CALIFORNIA COASTAL COMMISSION

**RECORD PACKET COPY****Th 9a****STAFF REPORT AND RECOMMENDATION****ON CONSISTENCY DETERMINATION**

Consistency Determination No. **CD-117-99**
Staff: JRR-SF
File Date: 12/16/1999
45th Day: 01/30/2000
60th Day Extended to: 8/17/2001
Commission Meeting: 8/9/2001

DEVELOPMENT**DESCRIPTION:**Lower Mission Creek flood-control improvements
(Exhibits 2-9)**EXECUTIVE SUMMARY**

VEGETATED SIDE SLOPE AND VERTICAL WALL SECTION VIEW

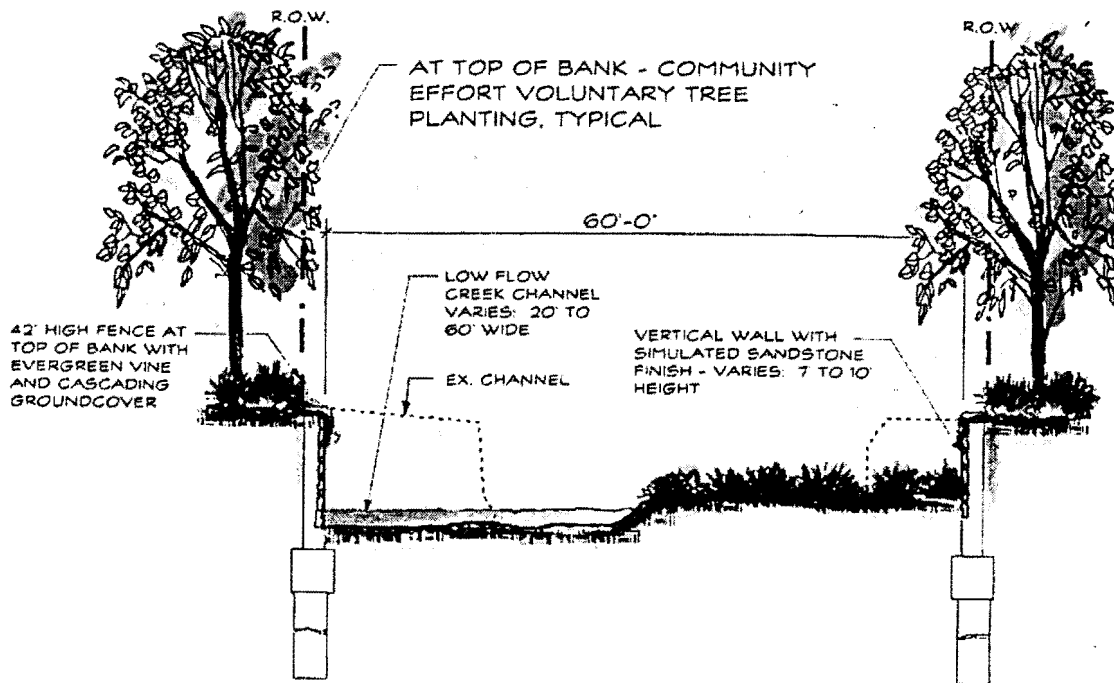
primarily of toe wall with vegetated riprap slopes. In a response to concerns raised by Commission staff, the City of Santa Barbara sent a letter explaining why a flood-control alternative that uses vegetated slopes within the coastal zone is not feasible (Exhibit 10). The City argues that such an alternative would require substantial acquisition of land and significantly increase the cost of the project. Additionally, the City would be required pursuant to state and federal law to mitigate for impacts to low-income housing and historic resources. That mitigation would also substantially increase the cost of the facility. According to the City, the cost increases required for such an alternative would result in a benefit-cost ratio of less than one,⁷ which means that the Corps could not fund the proposal. Therefore, the City concludes that that alternative is not feasible. The Commission does not consider its determination of feasibility to be constrained or governed by the Corps' cost benefit analysis. Nevertheless, in this case, the Commission agrees with the City that the alternative described above is infeasible, and that alternatives that are feasible are not less environmentally damaging, as discussed below.

EXHIBIT 1
42' LMC July Noon
@ 5 to 10 Years

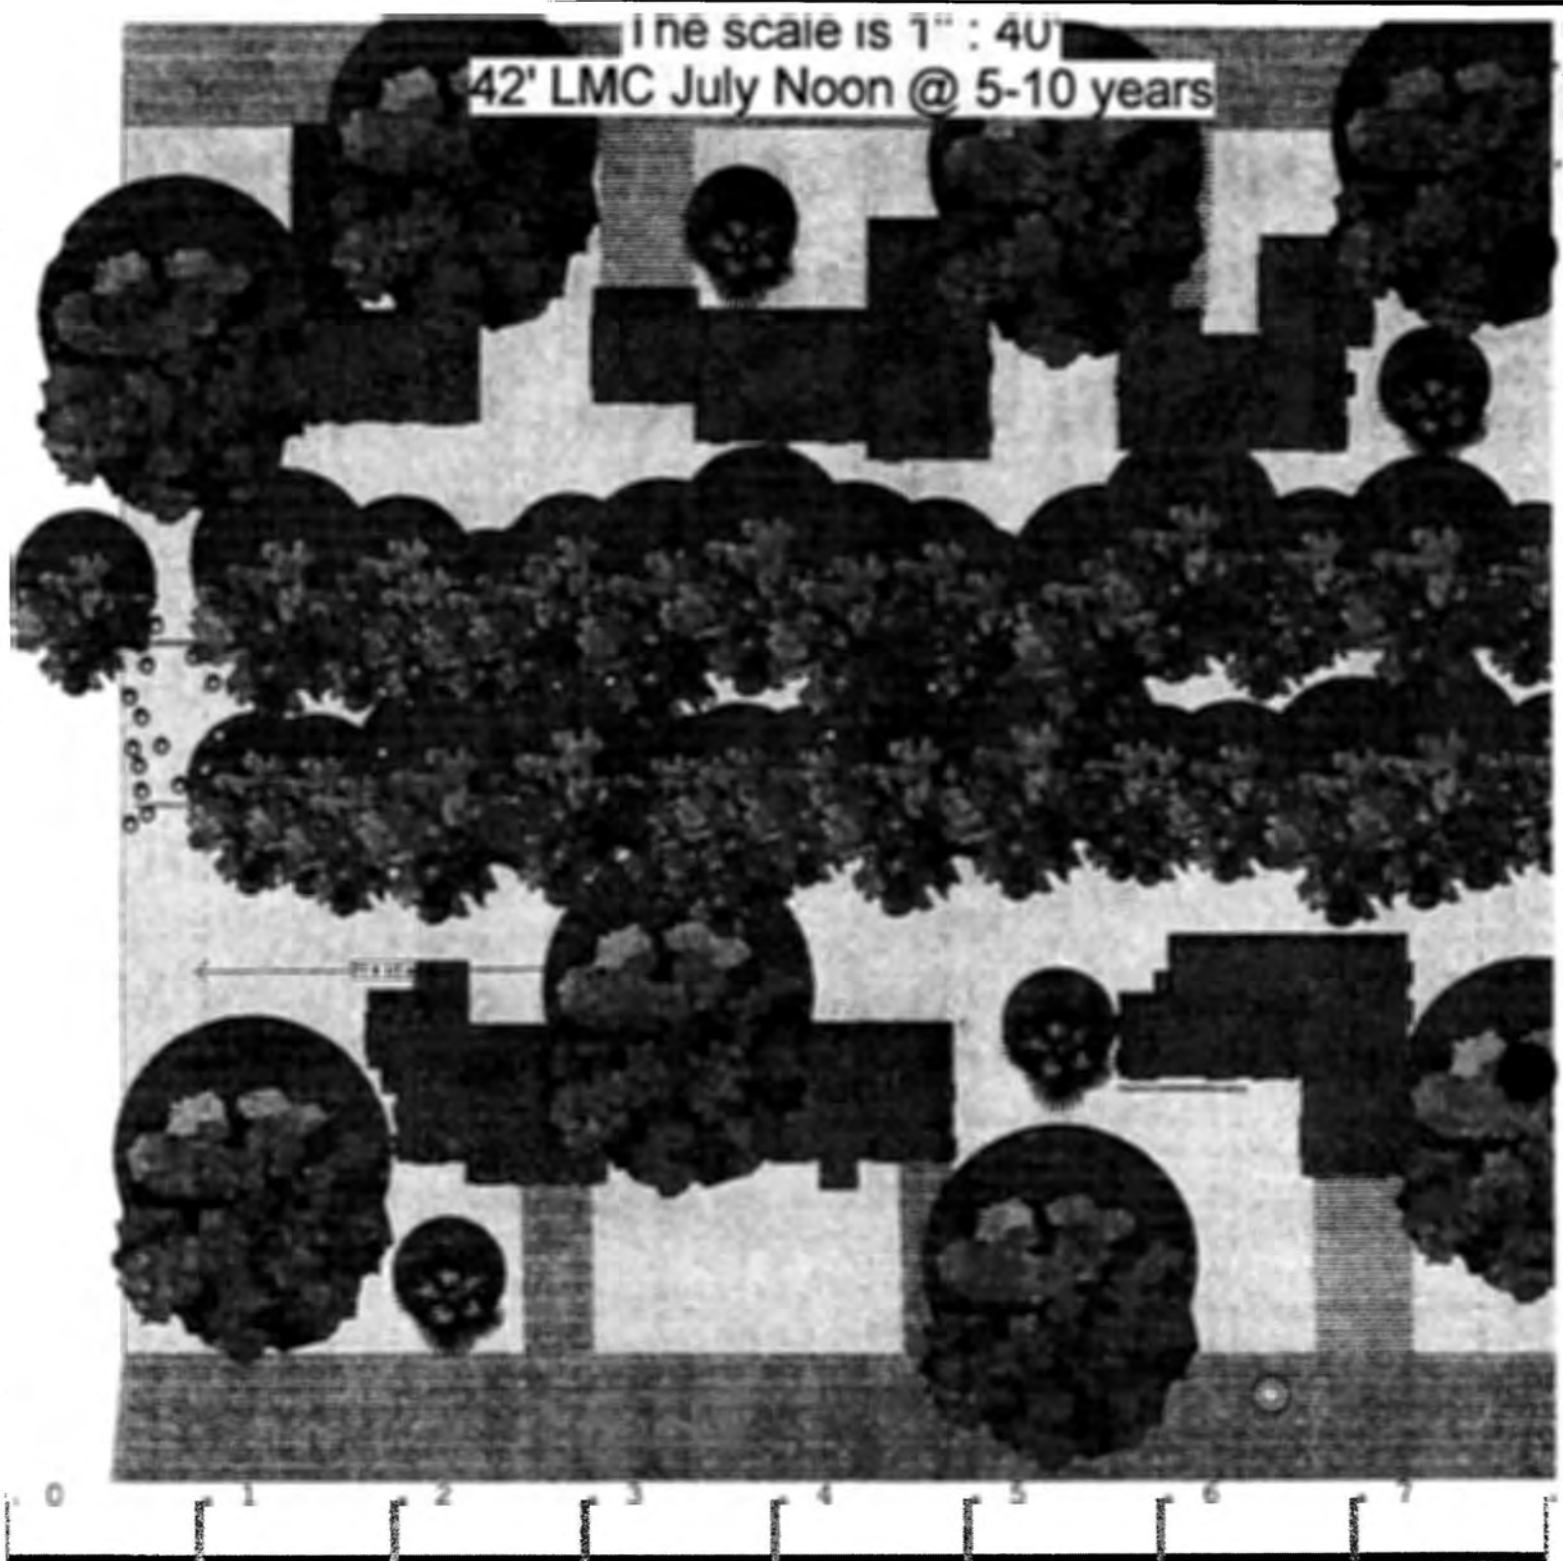
For the section above the freeway, a plan view is attached as Exhibit 1. The plan view is for trees that have grown 5 to 10 years. The view shows the extent of shade produced by these trees in July. Also provided are two 3-D pictures showing the size of the trees in 5 to 10 years (Exhibit 2) and the trees in 20 to 30 years (Exhibit 3). This analysis clearly indicates that the proposed planting of sycamore and willow trees will completely shade
